PRAIRIE ISLAND NUCLEAR GENERATING PLANT
UNITS 1 AND 2

Improved Technical Specifications
Conversion Submittal

PACKAGE 3.1
REACTIVITY CONTROL SYSTEMS
PART A
INTRODUCTION

LICENSE AMENDMENT REQUEST DATED December 11, 2000 **Conversion to Improved Standard Technical Specifications**

Figure 3.1.4-1 (page 1 of 1)
Moderator Temperature Coefficient vs. Power Level

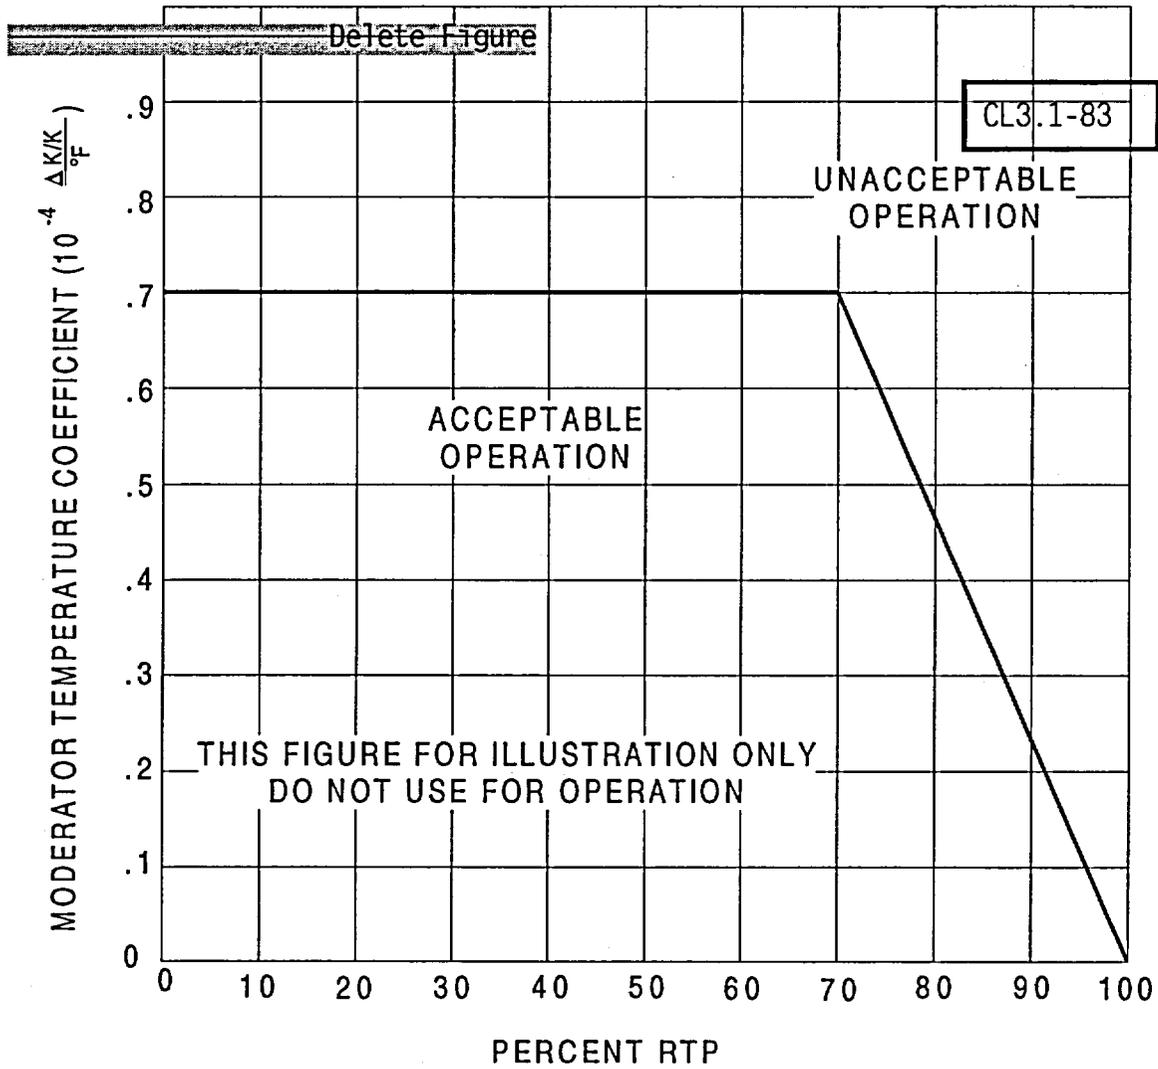
CL	83	The PI CTS specific ITC limits have been included explicitly in the LCO in lieu of reference to a figure. Thus, NUREG-1431 Figure 3.1.4.1 is not included in the PI ITS. These ITC limits have been approved for use at PI and assure that the plant operates safely at all power levels. The presentation of the LCO statement has been revised for clarity.

Figure B 3.1.7-1 (page 1 of 1)
Control Bank Insertion vs. Percent RTP

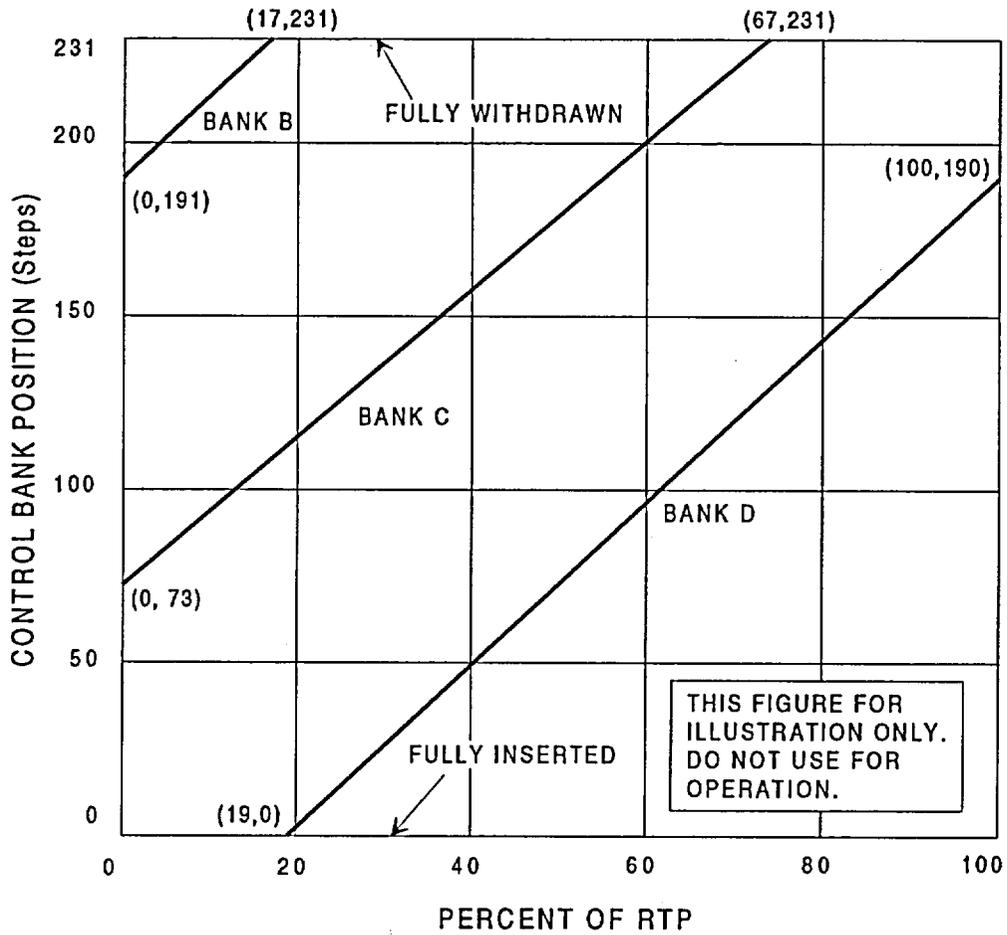
The control bank insertion limits are specified in a figure in the COLR. ~~An example is provided for information only in Figure B 3.1.7-1.~~ The control banks are required to be at or above the insertion limit lines.

~~Figure B 3.1.7-1 also indicates how the control banks are moved in an overlap pattern. Overlap is the distance travelled together by two control banks. The predetermined~~

~~This figure is deleted~~

PA3.1-192
